Planning Assessment Officer Report

PA2604207 – 41-45A Railway
Parade, Murrumbreena

Key Information	Details																														
Application No:	PA2604207																														
Received:	4 February 2026																														
Applicant:	Housing Choices Australia C-/ Tract Consultants																														
Planning Scheme:	Glen Eira																														
Land Address:	41-45A Railway Parade, Murrumbeena																														
Proposal:	To construct a 4-storey apartment building containing 86 dwellings, to remove and vary existing easements and remove canopy trees.																														
Development Value:	\$ 35m																														
Why is the Minister responsible?	In accordance with Clause 72.01-1 of the Planning Scheme, the Minister for Planning is the responsible Authority for this application because the Minister for Planning is the responsible authority for matters under Divisions 1, 1A, 2 and 3 of Part 4 of the Act, and endorsement of, approval of or being satisfied with matters required by a permit or the scheme to be endorsed, approved or done to the satisfaction of the responsible authority, in relation to the u

Figure 6 – Diagram of streetscape elevation showing the overall building height with compliant side setbacks and appropriate separation

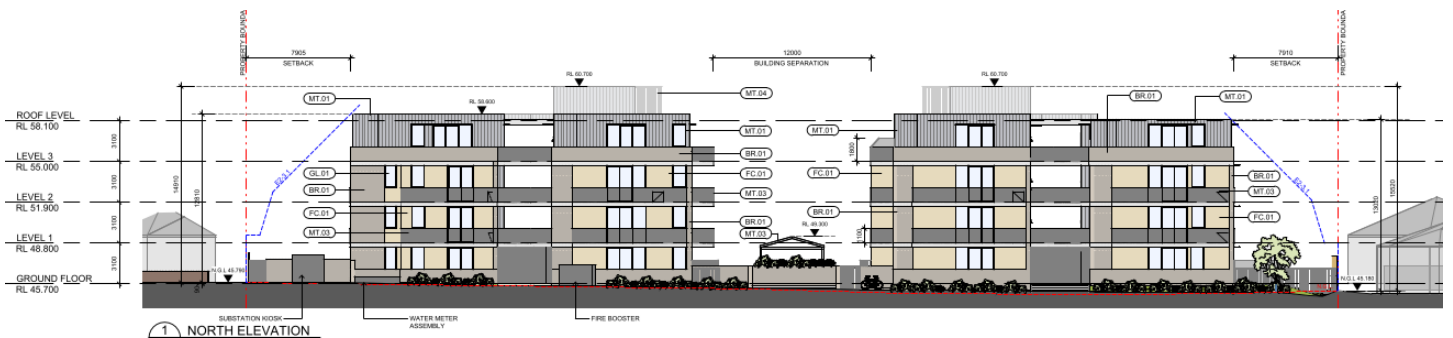
62. In terms of the overall massing, in close range views, the form will be largely perceived as 3-storey (noting that the 4th storey is setback from the streetscape) but will present as 4-storeys in longer range views. This is acceptable given that in longer range views, the height will not cause any unreasonable visual bulk impacts.

63. Additionally, the building setbacks and internal separation further break up the built mass into 'segments' providing visual interest and relief in the built form.

Figure 7 – Typical east-west section through the site showing compliance of the development from both side boundaries

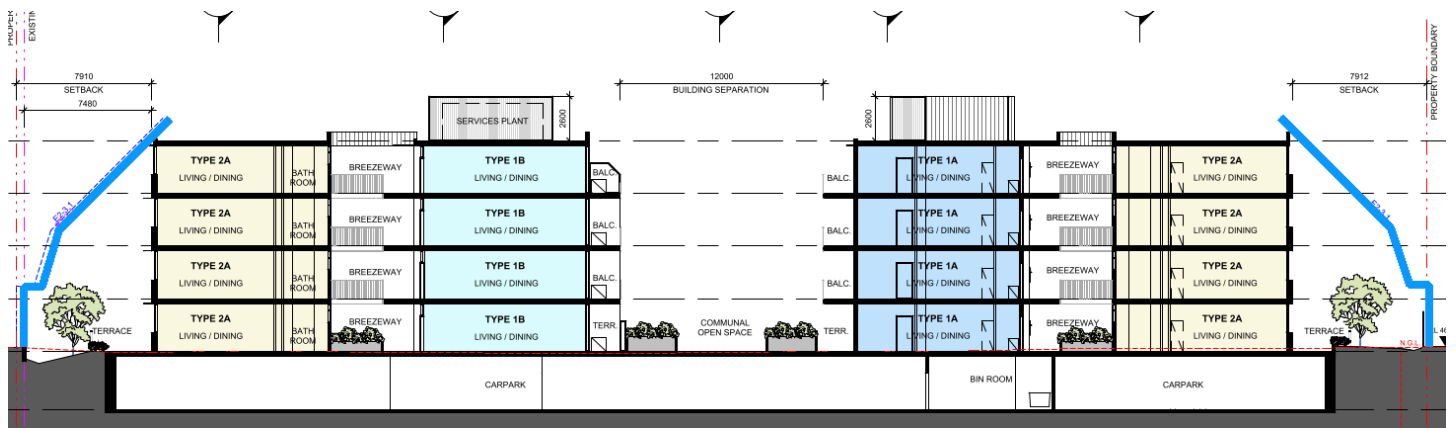
70. Along both side boundaries (east and west), the building has a minimum setback of approximately 7.9 metres. This complies with the requirements of standard E2.3-1 and will facilitate generous landscaping outcomes at the ground floor.

Figure 8 - Typical north-south section showing the compliance the building from the rear boundary. Two compliances are shown due to the staggered nature of the rear boundary.

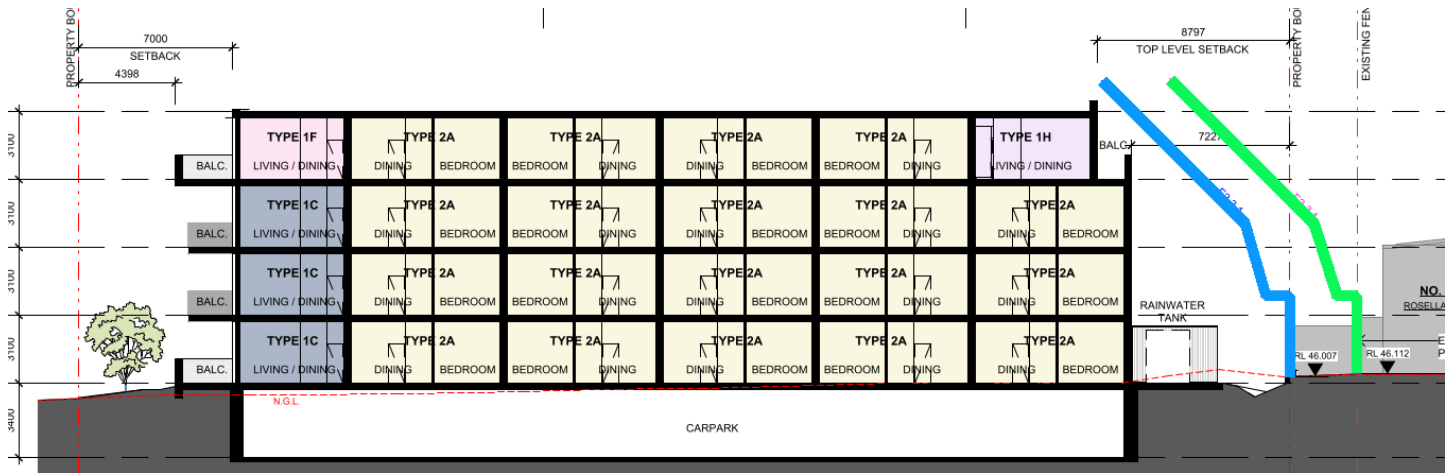
71. Along the rear boundary the setbacks vary due to the irregular title boundary as a result of the easement. Nonetheless, the building is setback in accordance with standard E2.3-1.

Figure 9 - Extract from the UCR with explanatory diagrams showing how the design of the building has been derived

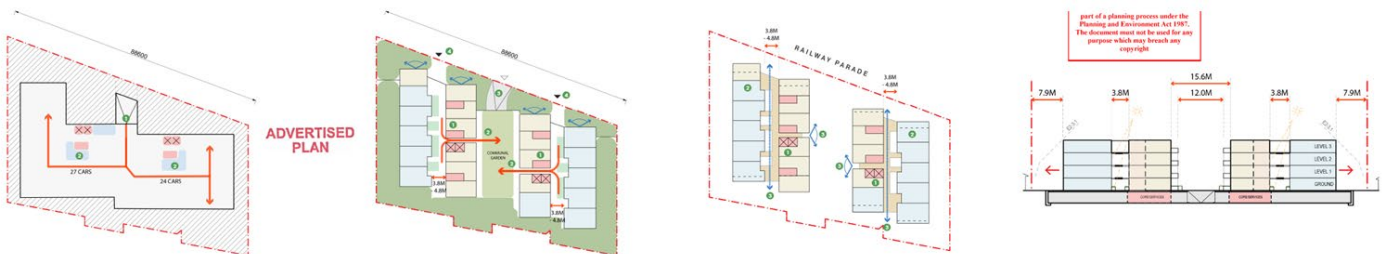
79. The UCR is satisfactory and confirms the proposal achieves a high degree of design quality, noting that:

- The built form is setback from the site boundaries to create distinctive modules which will break up the volume and massing. This provides a meaningful design entrance, creates articulation in the built form and emphasises the communal open space area.
- The building separation enables new landscaping opportunities to be created.
- The material palette is a combination of masonry and metal cladding, which appropriately balances neighbourhood character while providing a contemporary built form.
- The basement car parking has been sensitivity integrated within the overall design ensuring that the car parking structure is appropriately hidden from the public realm.

Figure 10 - Extract of asset information showing the relevant stormwater pipe within the subject site.

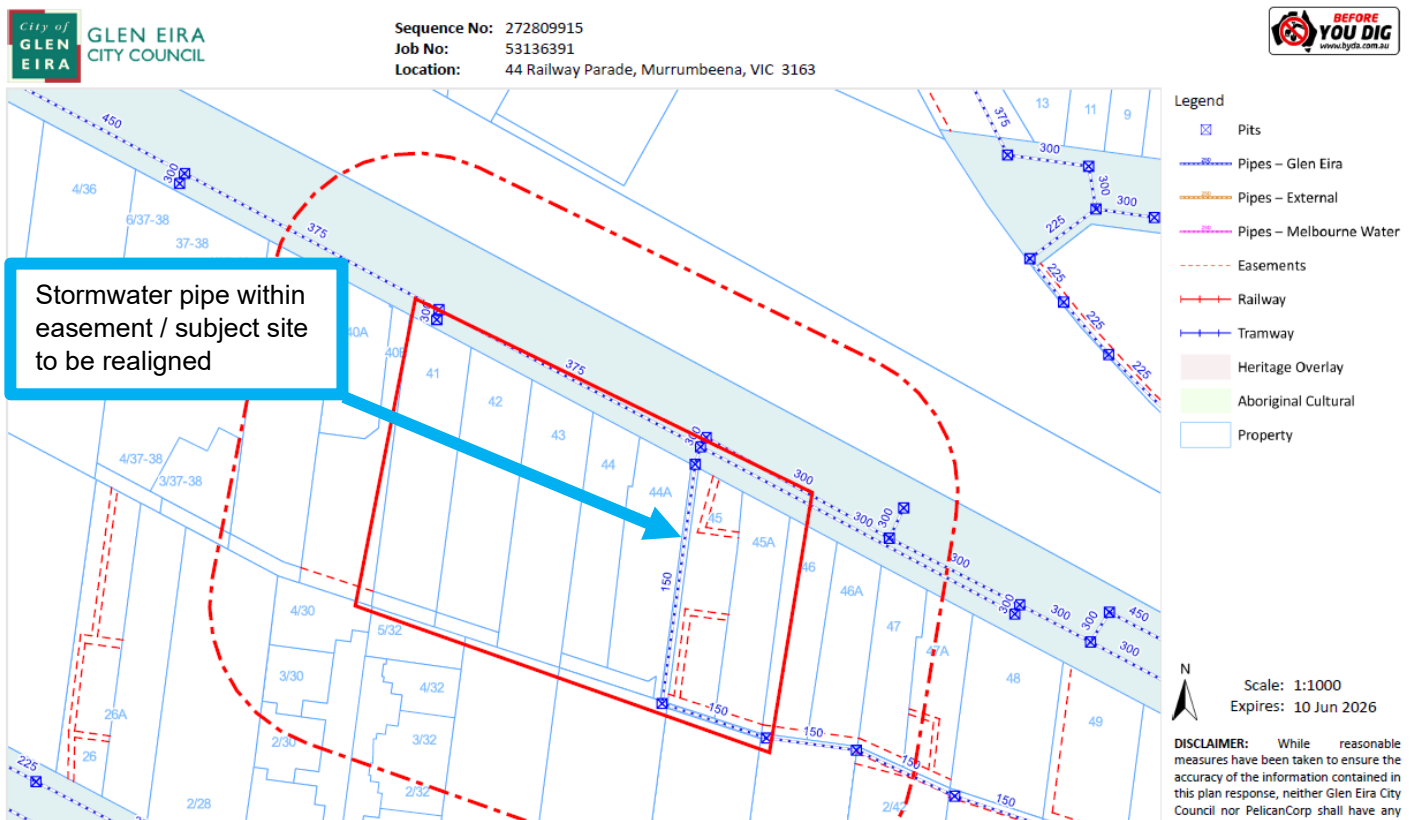
105. With respect to drainage easements in favour of Glen Eira City Council, it is understood that the easement currently contains assets within the easement. The council did not provide any comments regarding the application.

- b. The applicant has undertaken preliminary discussions with Glen Eira City Council's engineering division and has verbally advised that decommissioning of the stormwater pipe and consequential realignment is supported.

- c. The council has not provided any formal comment on this application, though, DTP officers consider that the verbal feedback provided by the applicant to be credible given that that branch of stormwater pipe is contained wholly within the subject site and its realignment will not cause unreasonable disruption to the broader stormwater network.
